Proposal #15: 1053-07-61
Wausau - Wittenberg
CTH Q to Bass Lake Road, WB
STH 29
Marathon County

This is Addendum No. 01, which provides for the following:

ADDENDUM NO. 01

Addendum No. 01
ID 1053-07-61
Revised Sheet 10
August 4, 2025

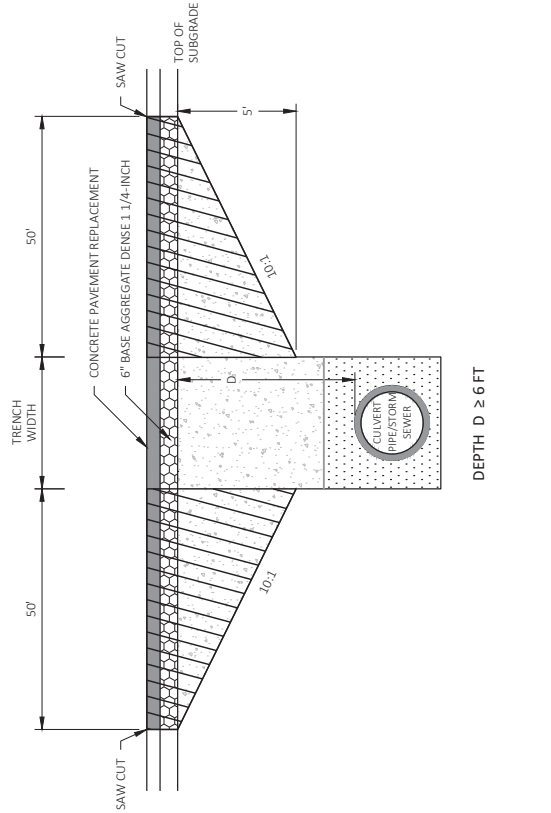
Revised Plan Sheets	
Plan Sheet	Plan Sheet Title (brief description of changes to sheet)
10	Construction Details (revised detail title)
34	Storm Sewer Plan (revised masking and annotations)
35	Storm Sewer Plan (revised annotations)
36	Storm Sewer Plan (revised masking and annotations)
68	Miscellaneous Quantities (switched bid item for culvert pipe)

TRANSITION CUT IS PAID AS EXCAVATION COMMON.
TRANSITION CUT WIDTH IS FROM SUBGRADE SHOULDER POINT TO SUBGRADE SHOULDER POINT.
BACKFILL THE TRANSITION CUT AREAS WITH FOUNDATION AND TRENCH BACKFILL AS SPECIFIED IN STANDARD SPEC 520.
PERFORM CULVERT PIPE INSTALLATION BEFORE MILLING AND PAVING.

ROUTE	STA (CL)	DEPTH D (FT)	PIPE DIA (IN)	REMARKS
STH 29	684+59	≈ 8'	36	STORM SEWER PIPE REINFORCED CONCRETE CLASS III 36-INCH
STH 29	686+14	≈ 8'	36	STORM SEWER PIPE REINFORCED CONCRETE CLASS III 36-INCH
